AGENDA
MAPLE PLAIN PLANNING COMMISSION
MAPLE PLAIN CITY HALL
Tuesday, October 21, 2014, AT 7 p.m.

Request by Schumacher Properties for Site Plan Review to Allow Retail Use of the Existing Building Located on the Property at 5030 Highway 12

To:	Planning Commission
From:	Mark Kaltsas, City Planner
Meeting Date:	October 21, 2014
Applicant:	Schumacher Properties
Owner:	Schumacher Properties
Location:	5030 Highway 12

Re: Site Plan Review – Liquor Depot

2 EAST ELEVATION

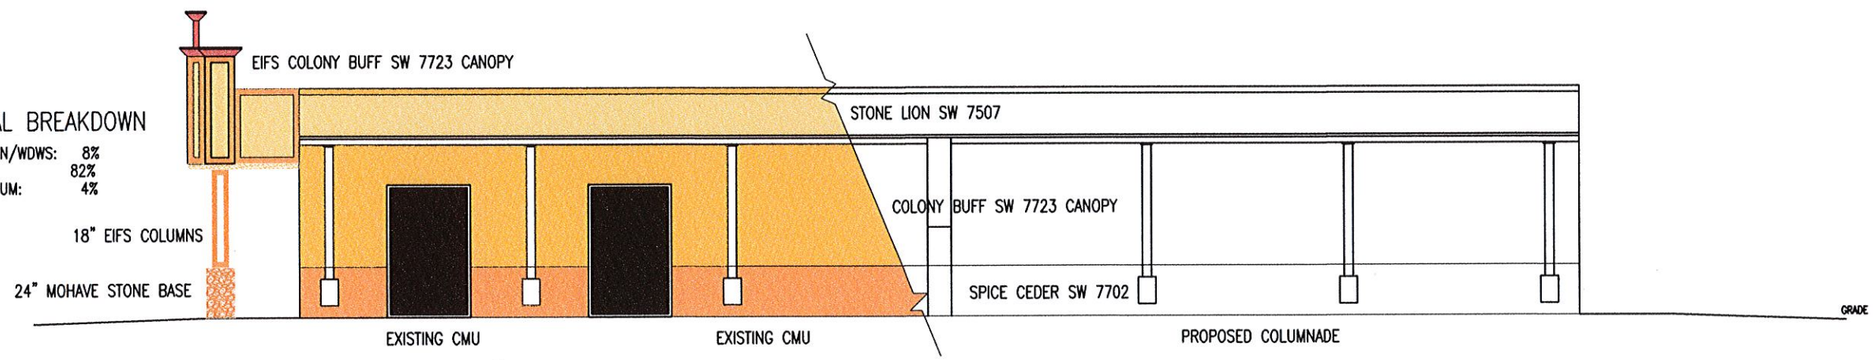
1. The Planning Commission would like to verify all of the proposed colors for the building. Commissioners also wanted to confirm that the existing brick on the south elevation of the building would remain unpainted? Please provide the City with color samples and additional detail on the building elevations delineating the intended colors and materials.

2. The proposed columns appear to provide some additional architectural relief to the south building elevation. The Planning Commission would like to see the base of the columns enlarged and constructed out of a masonry material rather than EIFS (i.e. a matching brick).

The applicant has stated that they will bring/provide samples for the Planning Commission Meeting. The revised building elevations plans now specify the actual colors for each elevation and building material.

The applicant has proposed to use a stone base rather than the EIFS as previously proposed. The columns appear to be the same dimensions as those originally proposed. The applicant has provided a proposed dimension for the columns (24" in width). The size of the column bases may appears to align with the edge of the existing overhang.

1 TRASH ENCLOSURE PLAN
1/4" = 1'-0"

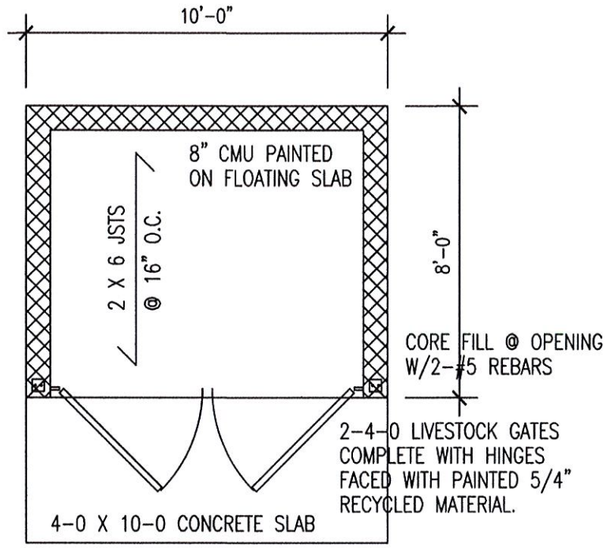
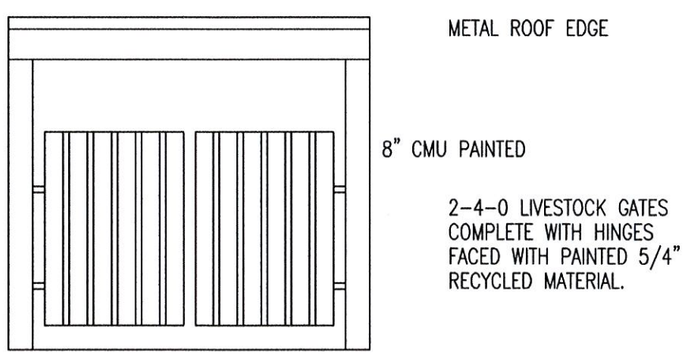
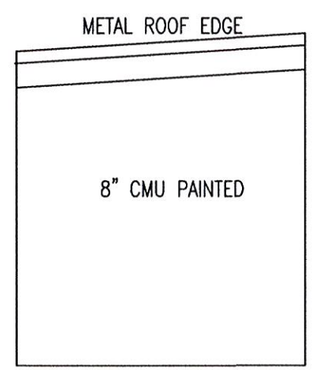
8. The trash enclosure detail will need to be provided which identifies the structure and proposed buildings materials. The enclosure should be located such that the fire department can access the north side of the building with its vehicles.

The applicant moved the proposed trash enclosure away from the building and provided a detail for review by the City. The applicant is proposing to construct a masonry block enclosure that would be painted to match the building.
